Office of Development Assistance
15151 E. Alameda Parkway, Suite 5200
Aurora, Colorado 80012
303.739.7345

March 18, 2021

**Re: Murphy Creek PA 13, 14 and 9C (#1520958)/Pre-Application Meeting held March 04, 2021
RESPONSES PROVIDED JUNE 25, 2021 BY MERITAGE HOMES. INNOVATIVE LAND
CONSULTANTS AND HENRY DESIGN GROUP.**

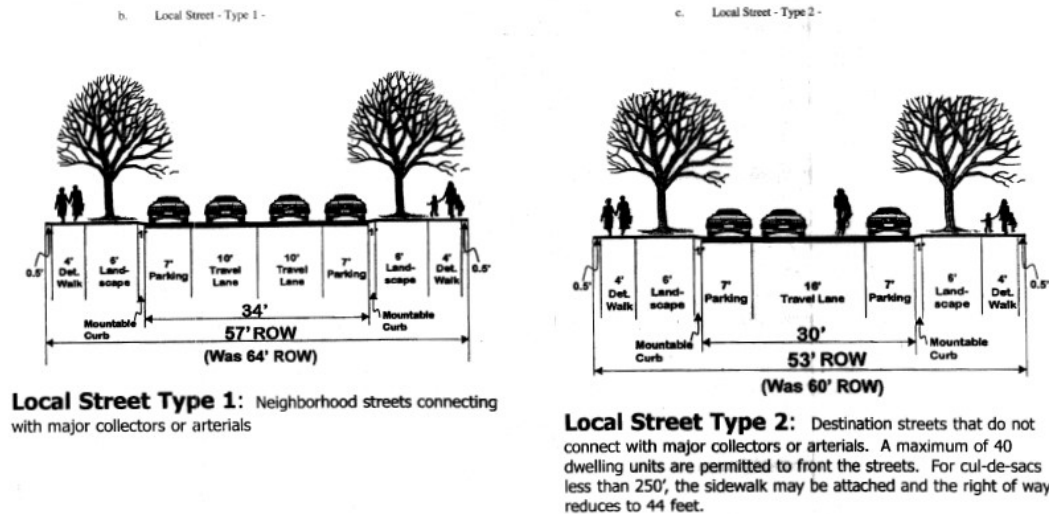
All blocks will be evaluated for a maximum block length of 700 feet and maximum perimeter of 2,800 feet (UDO Section 146-4.3.9).

Response: Noted as stated above an adjust to the 700 foot block length is requested. The street layout complies with the 2,800 feet.
